SUBJECT: 6.0L Power Stroke® Water Pump Identification

Reference: Alliant Power Application Guide Effective in Engines Built After July 19, 2004.
Ford® made a running change to 6.0L Power Stroke (all models except F-650 / F-750) water pumps and engine front covers. This change increases coolant flow in order to offset higher engine heat rejection. As shown in the photo below, the new pump AP63503 can be identified by a larger impeller diameter than the original pump AP63502. The front cover was updated as well to proportionally increase the water pump sealing area.

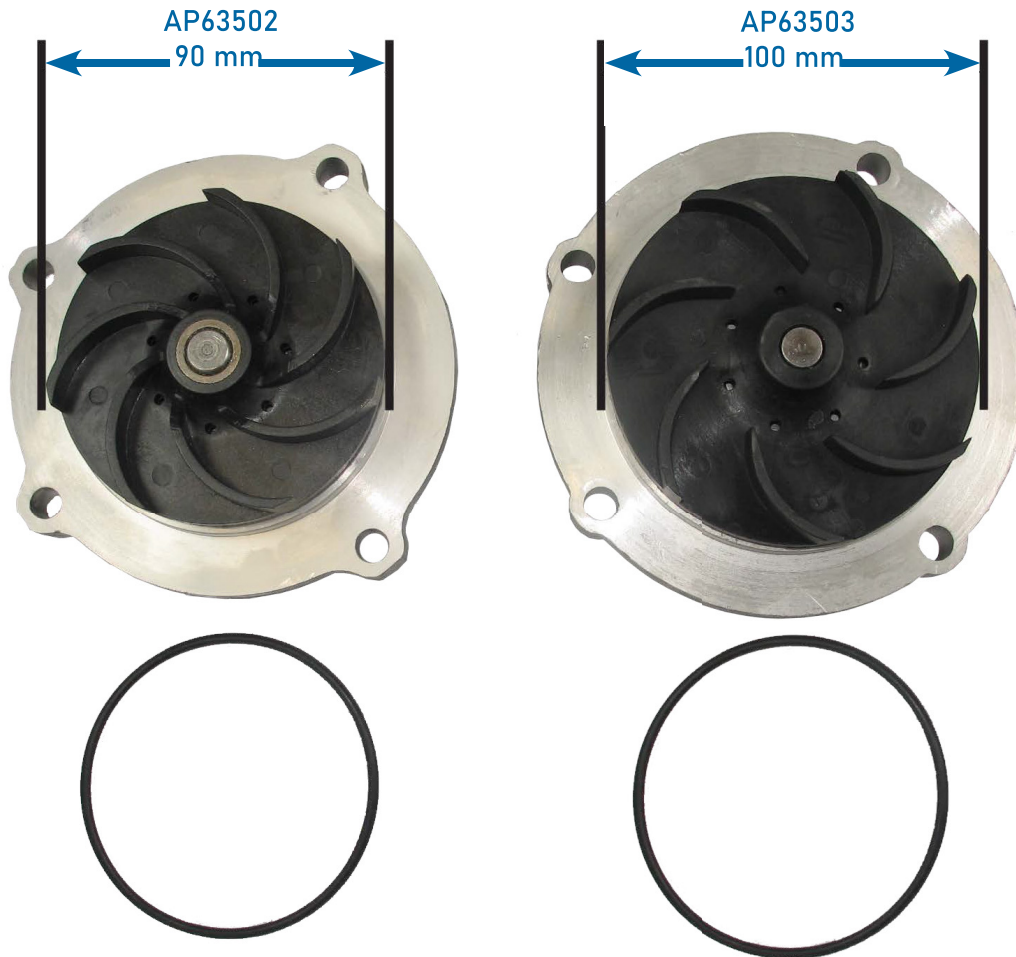
Caution: Both pumps have the same bolt pattern but different sealing areas. As a result, the original pump AP63502 could be inadvertently installed in place of a newer pump AP63503, likely resulting in coolant leakage and engine overheating. Because of different sealing areas, the new pump cannot be installed in place of the original pump.
